# ADDENDUM 03

<b>TO</b>	All Plan Holders	<b>ISSUE DATE</b>	23 November 2022
		<b>PROJECT #</b>	17-006.12
<b>REGARDING</b>	<b>Reroof &amp; Mechanical, Exterior Painting, Window Replacement at Mission Hill Middle School</b>	<b>NARRATIVE PAGES</b>	1
		<b>SPECIFICATION PAGES</b>	0
<b>DISTRICT</b>	Santa Cruz City Schools District	<b>DRAWING SHEETS</b>	3
		<b>TOTAL PAGES</b>	4

Floor Plan - Multi-purpose Room 1/8"=1'-0" 2

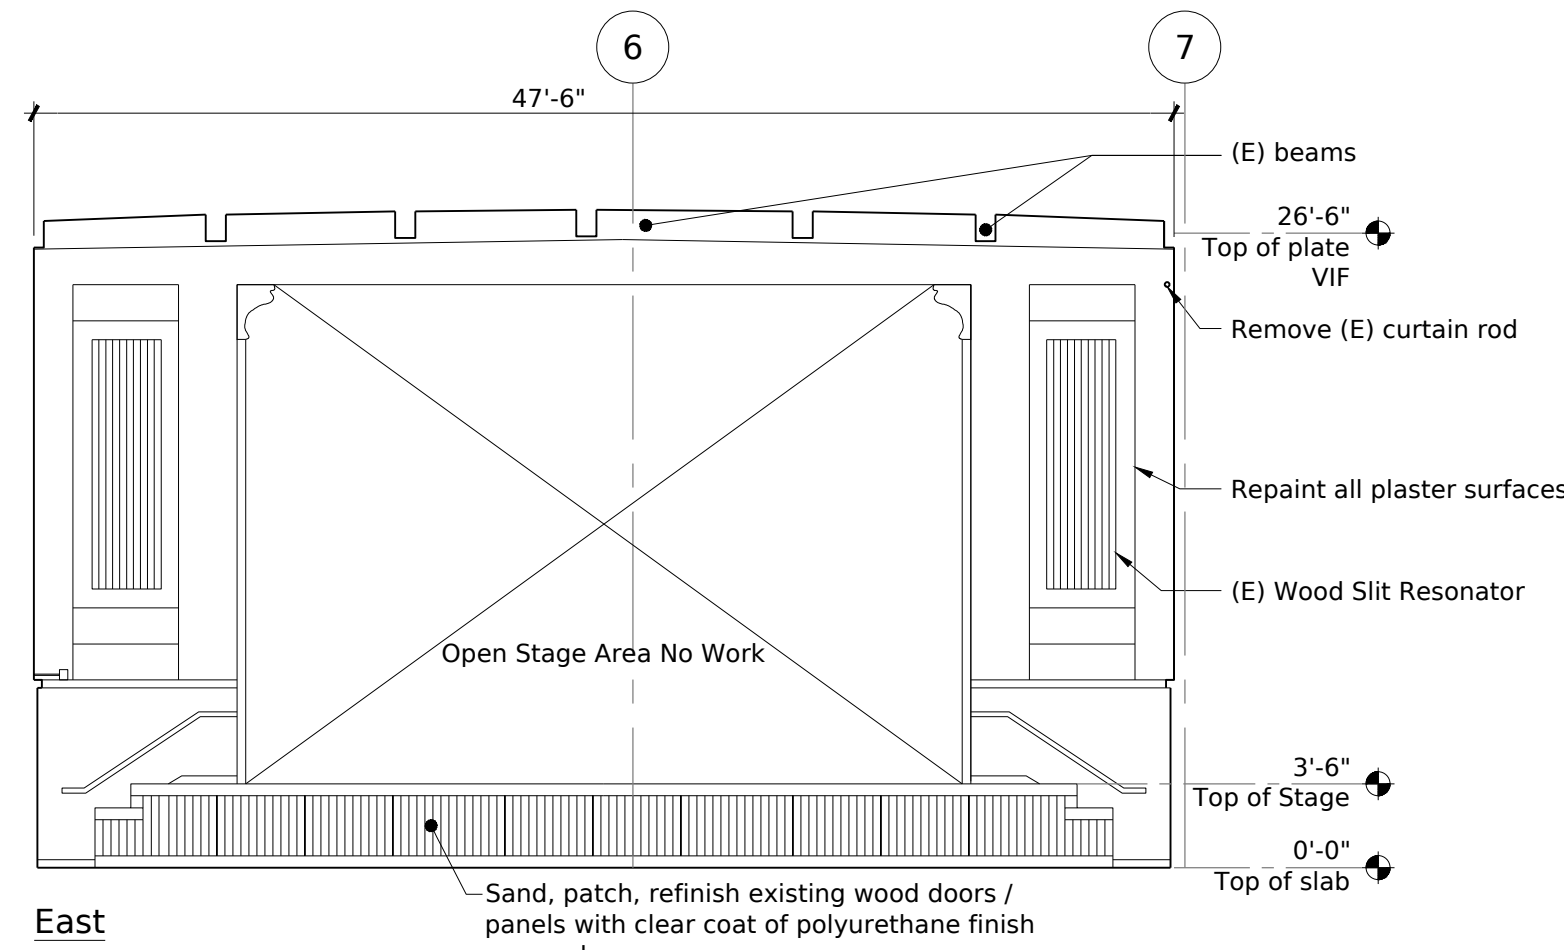
- 05** **AD2-MP1** • **Clarification** of scope of interior improvements at Auditorium. (multi-purpose room)
- AD2-MP-REF** • Refer also to addendum 01 for additional information related to scope at auditorium that still applies
- **Clarification:** Tack panel to be installed over 1x stripping to provide chase and cover all existing electrical conduits
- **Clarification:** Paintable pre-primed finger pine trim at all locations trim is indicated. Paint to match existing wood ceiling beams.
- Reference drawing from 1930 original construction with section and details is provided for reference.

**AD2-W1**

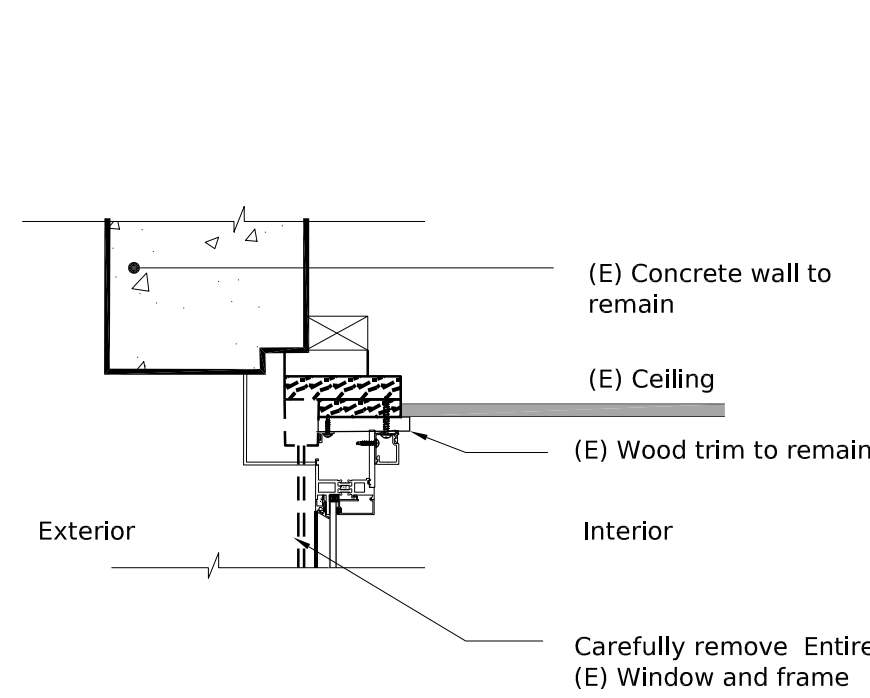
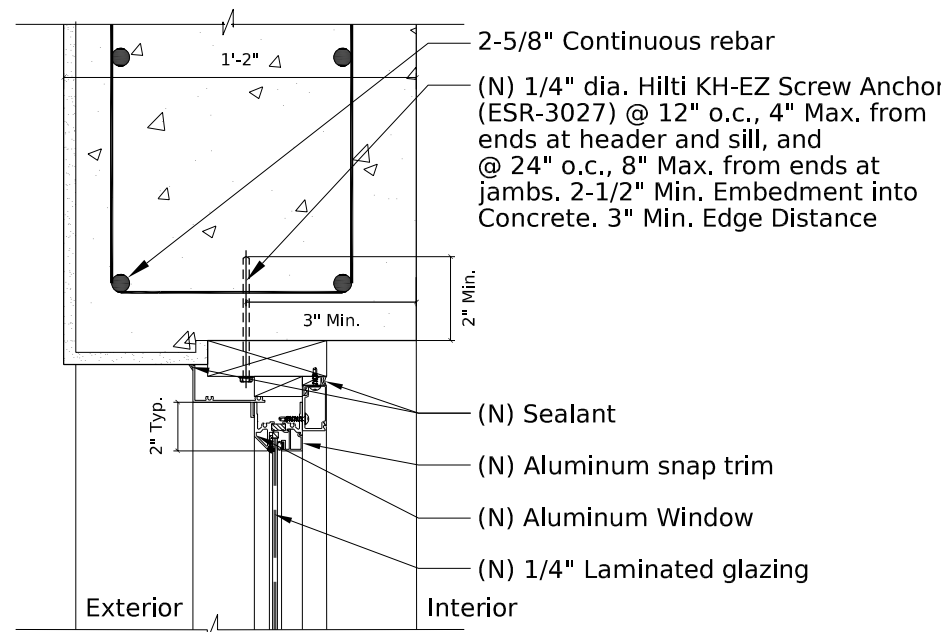
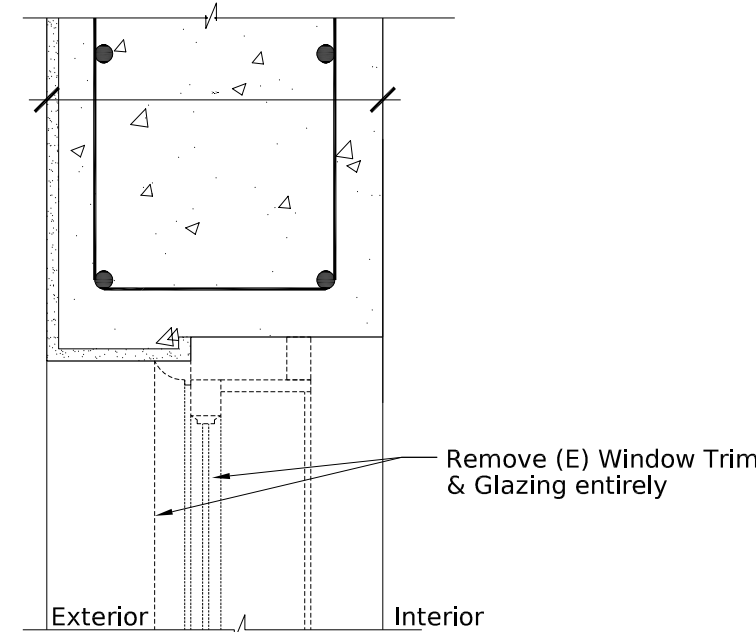
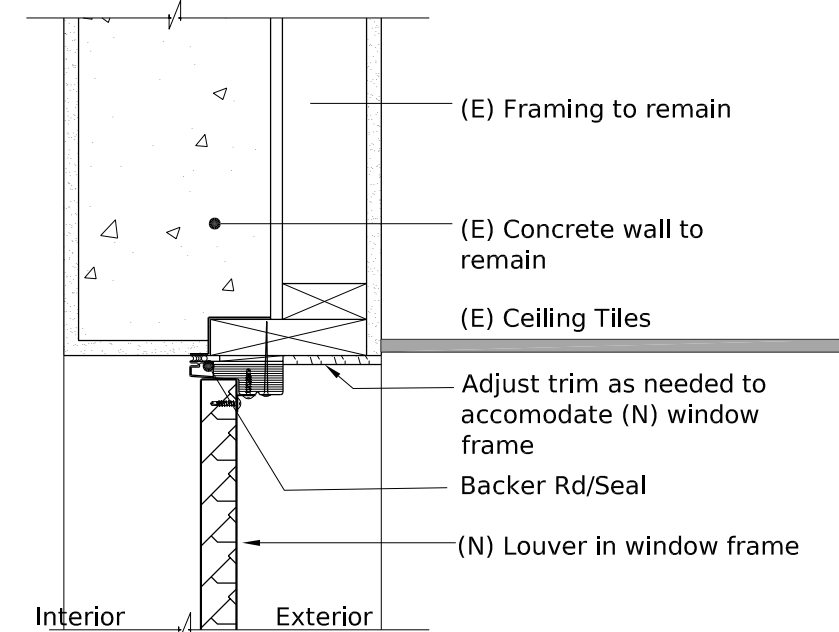
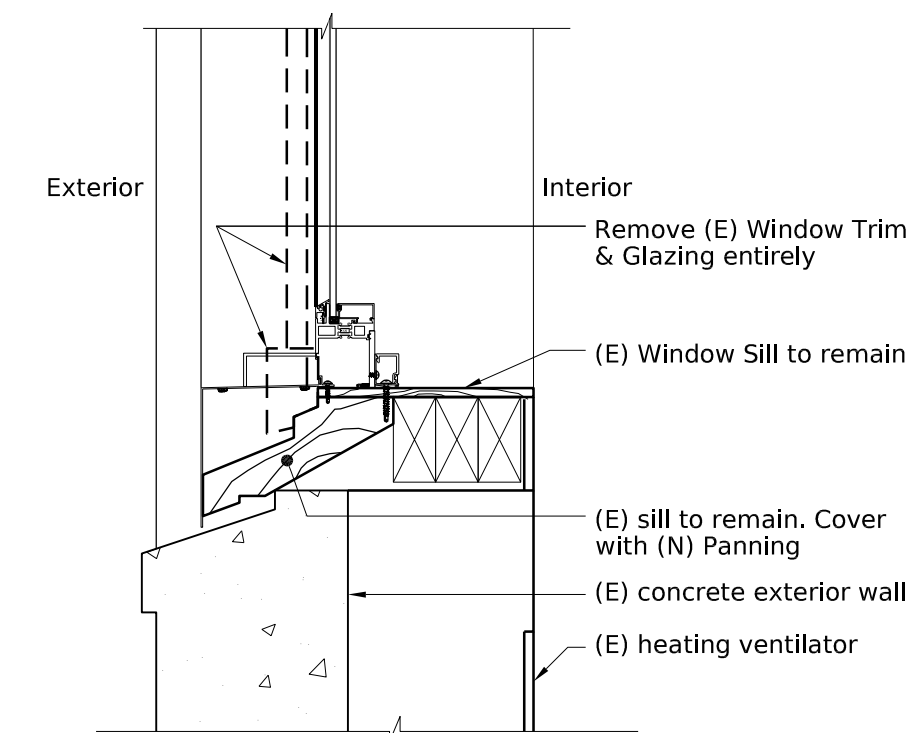
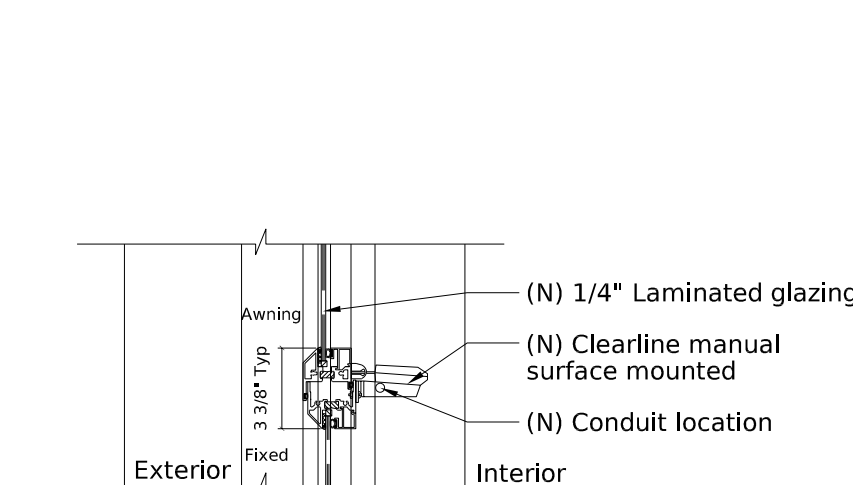
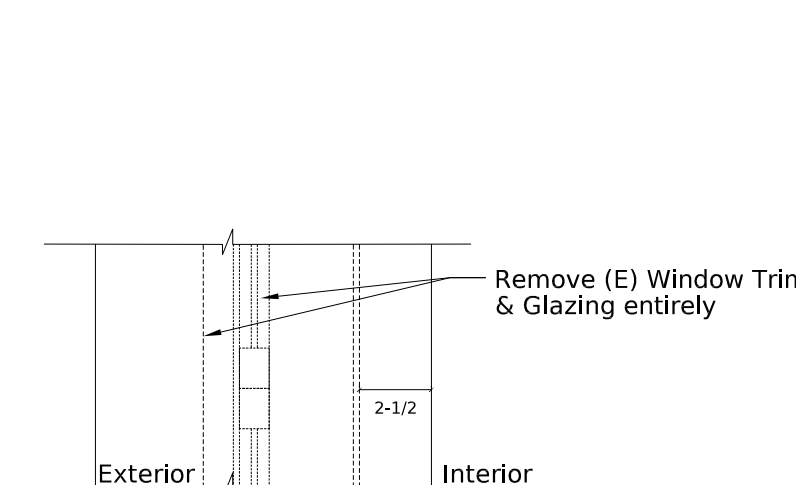
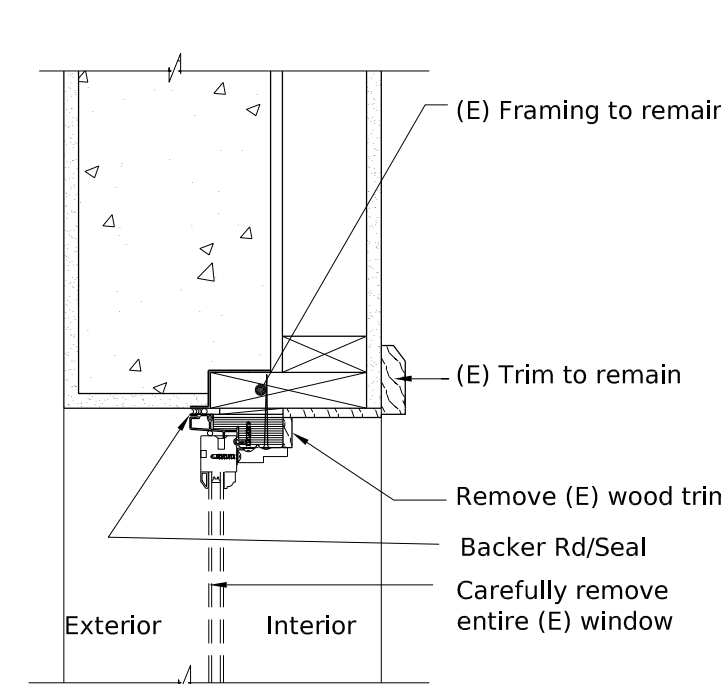
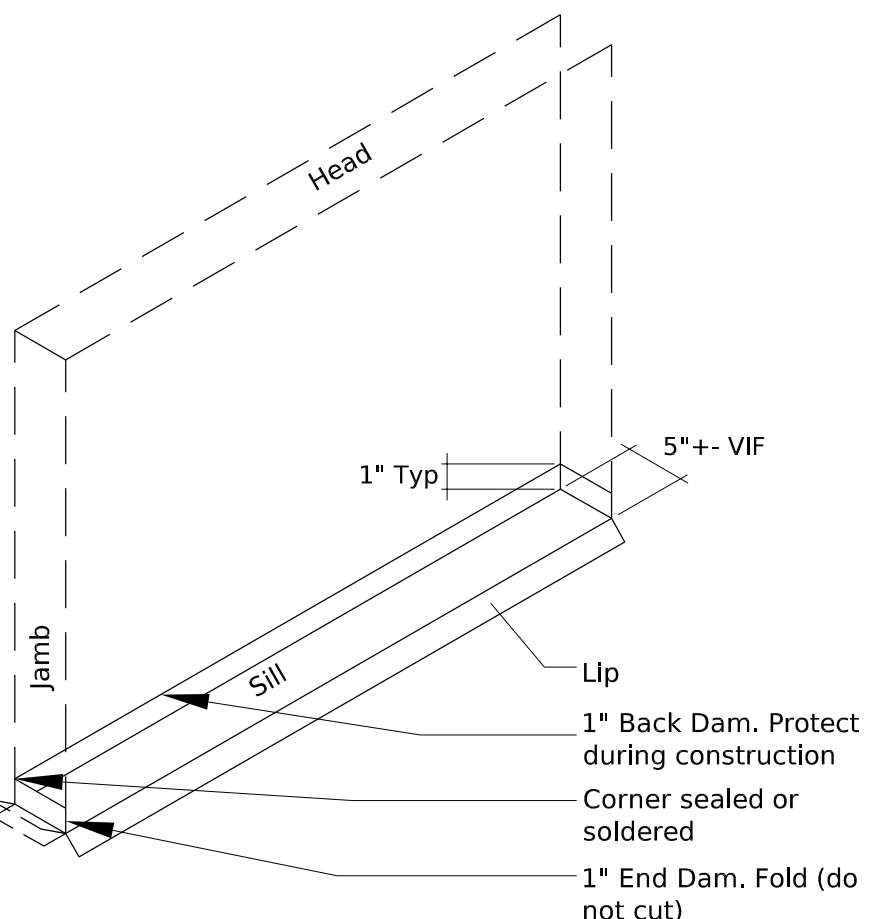
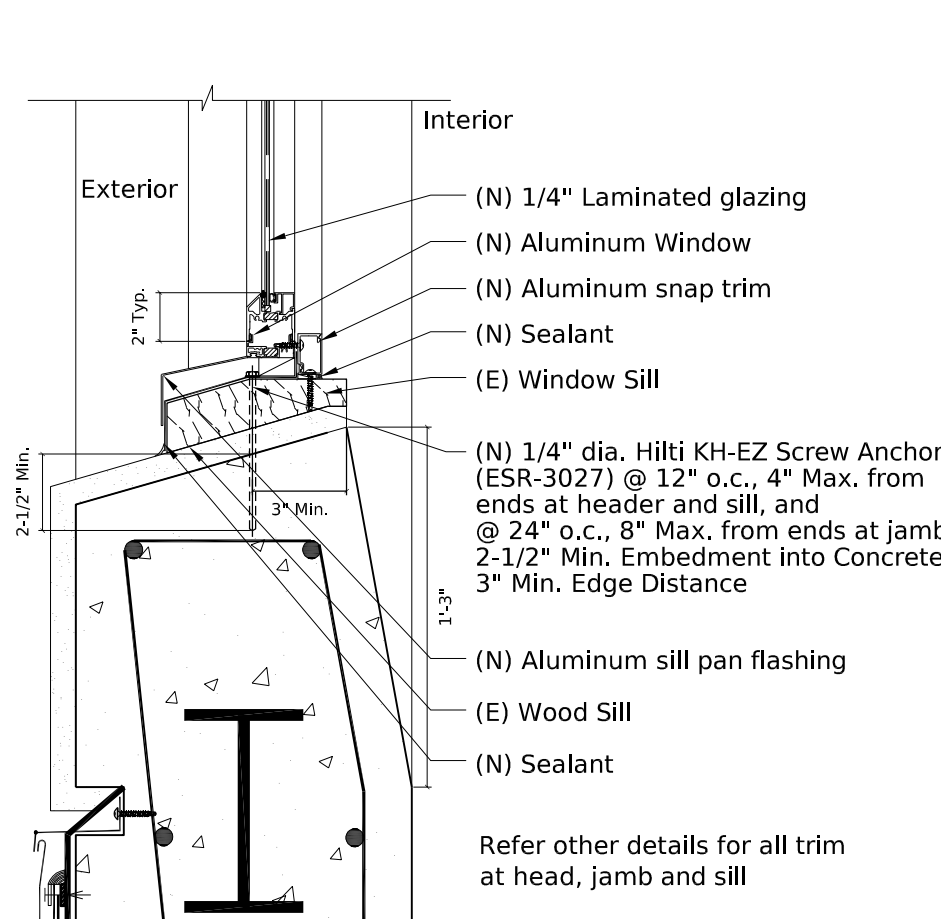
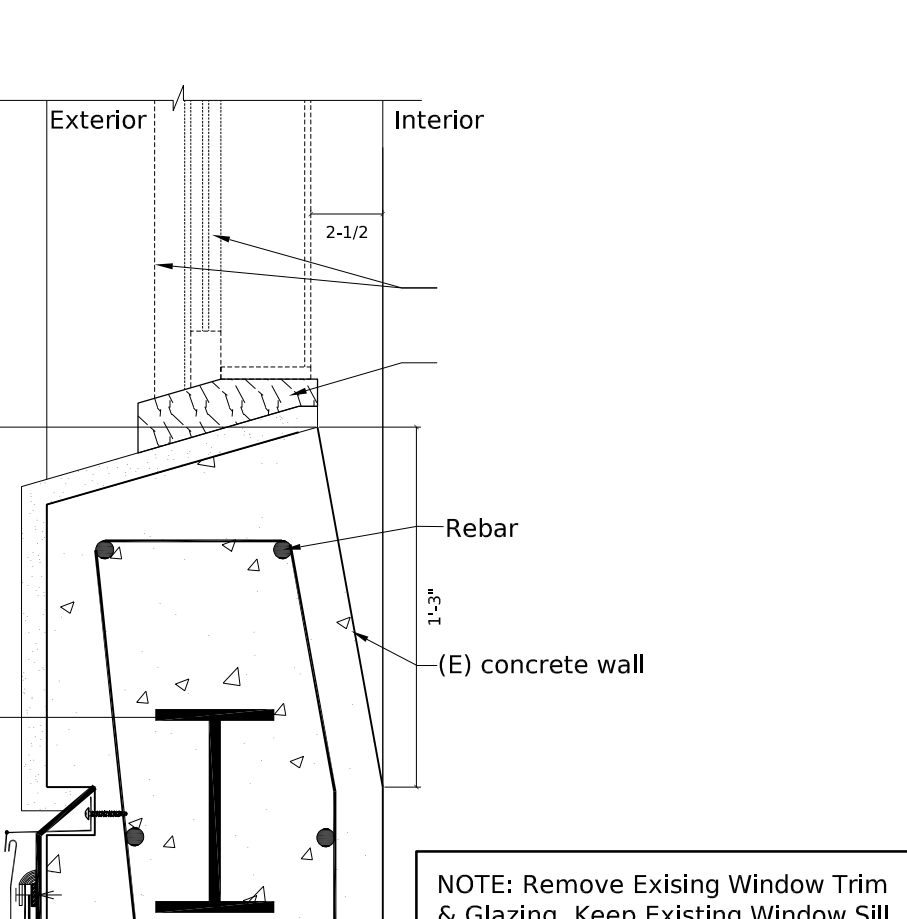
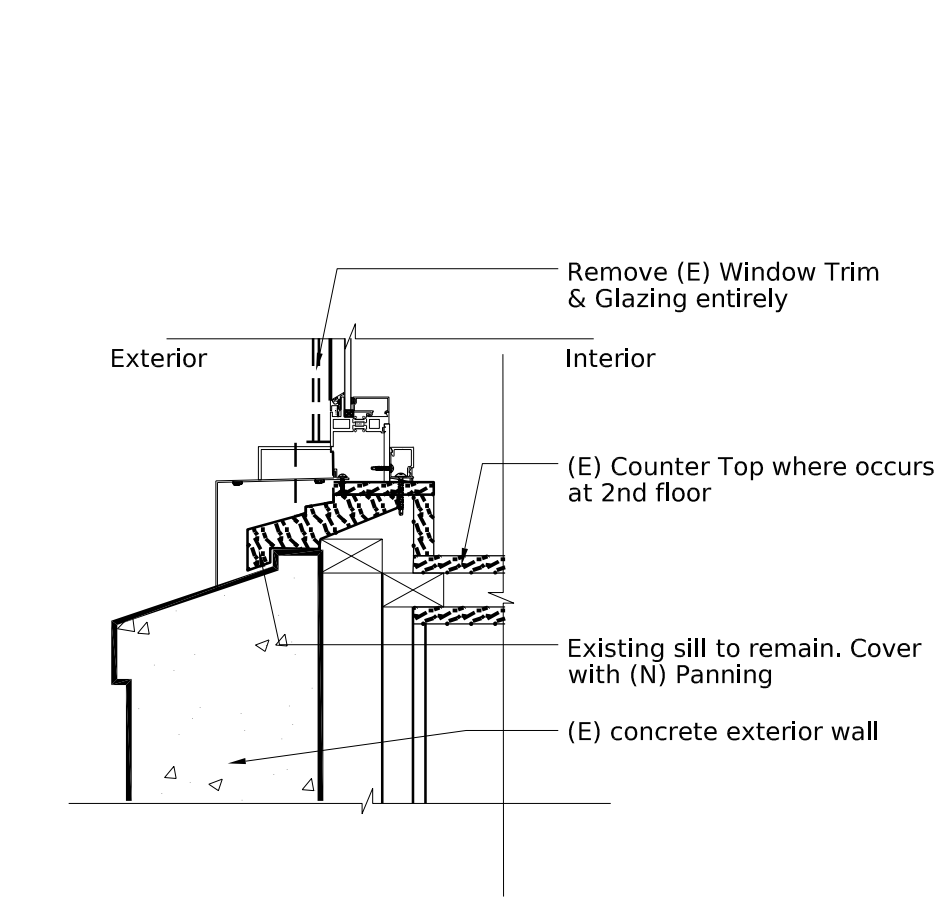
- Interior Trim at windows** • Clarification: Sheet A7.0 is hereby re-issued in its entirety as AD3-W1
- Provide panning over existing sills/jams/heads. Place over existing interior trims
- AD3-W1** • Base bid shall Include allowance **\$10,000** for wood trim necessary at special locations.
- Any new trims shall match existing dimension and profile
